Re: *Request for Correction of Information Submitted Under USGS
Information Quality Guidelines*

Publication: *Breault, R.F., 2011, "Concentrations, Loads, and Sources of
Polychlorinated Biphenyls, Neponset River and Neponset River Estuary,
Eastern Massachusetts: U.S. Geological Survey Scientific Investigations
Report 2011-5004, 143 p. (<http://pubs.usgs.gov/sir/2011/5004>)*

RE: Technical Review and Proposed Corrections – *Breault, R.F., 2011, "Concentrations, Loads, and Sources of Polychlorinated Biphenyls, Neponset River and Neponset River Estuary, Eastern Massachusetts: U.S. Geological Survey Scientific Investigations Report 2011-5004, 143 p. (<http://pubs.euqu.gov/sir/2011/5004>)*

Figure 1. Mother Brook Sediments Compared to Facility #2 Soils and Reference PCB Aroclors.

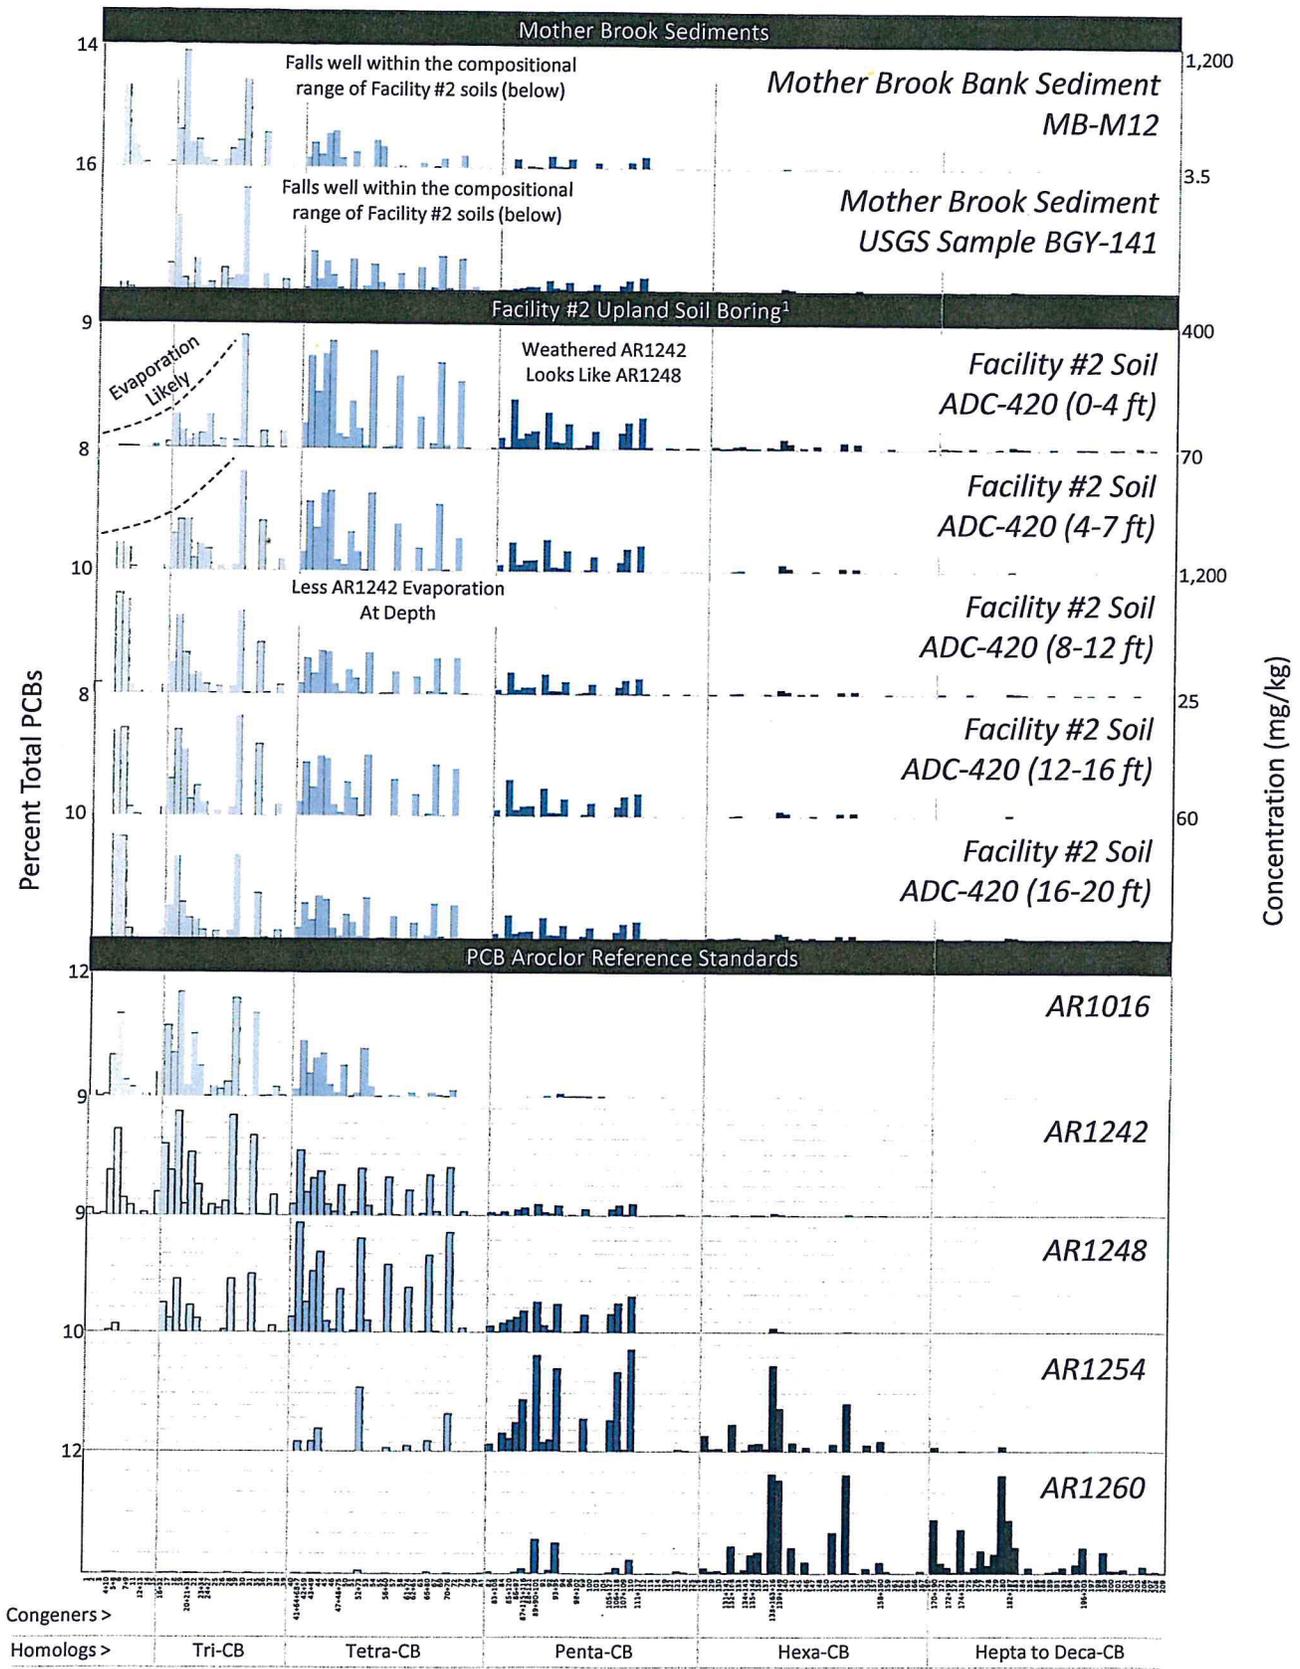
Figure 1 in this memorandum demonstrates that the chemical signature for Cluster 1 may indicate the presence of AR1254 and/or AR1260 while the chemical signature for Cluster 2 may indicate the presence of AR1016, AR1242, and/or AR1248. The ability of the HCA to identify specific PCB source(s) within the entire sample population is further confounded by environmental weathering. For example, evaporation can make lighter Aroclors, like AR1242, look heavier, like AR1254. Conversely, anaerobic dechlorination can make heavier Aroclors, like AR1254, look lighter, like AR1242. The HCA in this report is only capable of separating samples based on general compositional features potentially attributed several possible Aroclor sources and offers no insight concerning the potential effects of environmental weathering. HCA is poorly suited for identifying specific sources within the watershed.

Comment 11. *Various Conclusory Statements Regarding Facility #3 (see especially pages 9, 34 and 38).* In several places, the reports reflects a selective focus on facility #3 (in the concluding sentence of the Cluster Analysis section and elsewhere), which is not justified by the data. Like many areas in the Neponset Watershed, the Mother Brook tributary is bounded by multiple PCB sources. This report, however, not only selectively focuses on facilities #2 and #3, but also treats them as distinct sources of PCB releases, an assumption which is unjustified and erroneous. Three points warrant consideration here. First, facility #2 has multiple discontinuous soils with AR1016, AR1242, and AR1248 that demonstrate independent releases over time of trichlorobiphenyls and tetrachlorobiphenyls in close proximity to migration pathways to Mother Brook. A careful review of the PCB congener patterns demonstrates that Mother Brook sediments match well the PCB signatures in facility #2 soils, when multiple samples from multiple depths are considered¹. Figure 1 in this memorandum shows a comparison of congener

patterns from a USGS sediment sample (BGY-141), a Mother Brook bank sediment sample (MB-M12), and soil boring ADC-420 samples at varying depths taken from Facility #2 (Attachment 1). Figure 1 herein demonstrates that the PCB pattern variability among Mother Brook sediments matches closely the variability among facility #2 soils. Specifically, all of these soil and sediment samples are dominated by tri- and tetra-chlorobiphenyls. The most significant variability occurs within the mono-, di-, and tri-chlorobiphenyl homolog groups and is likely caused by environmental weathering; e.g., evaporation. In short, the PCB patterns among facility #2 soils match the Mother Brook sediments when environmental weathering is considered.

Second, the data for facility #3 does not reflect any significant AR1016, AR1242, or AR1248 releases near migration pathways to Mother Brook. The pipe that is suggested to have been a conduit for PCBs to migrate from facility #3 into Mother Brook, as referenced on page 9, paragraph 2 of the report, is submerged below the surface of Mother Brook, when seasonally flooded, such that PCBs carried by Mother Brook from upstream sources could be caught and collected in the open end of the pipe. In addition, we understand that this pipe was installed in the 1970s when facility #3 was converted to use as a supermarket building, and it was not in existence during any time period when circuit breaker production or other industrial activities involving PCBs may have taken place at facility #3. In other words, that pipe was installed at facility #3 far too late in time to have served as an historical conduit for PCB releases associated with industrial operations (Haley & Aldrich, 2009). Therefore, the PCBs that were reportedly measured in the referenced pipe at facility #3 likely indicate the presence of re-suspended upstream sediments that were forced into the pipe during flooding events. The oily nature of this sample is not well-documented, but may indicate the co-occurrence of a chronic petroleum pipe discharge (as opposed to PCBs) or sheen attributed to upstream runoff. PCBs measured in the sediment and on the banks of facility #3 (e.g., MB-M12 is surface sediment from the bank of Mother Brook

[Figure 1 of this memorandum]) likely came from upstream sources during storm events and periods of high water.
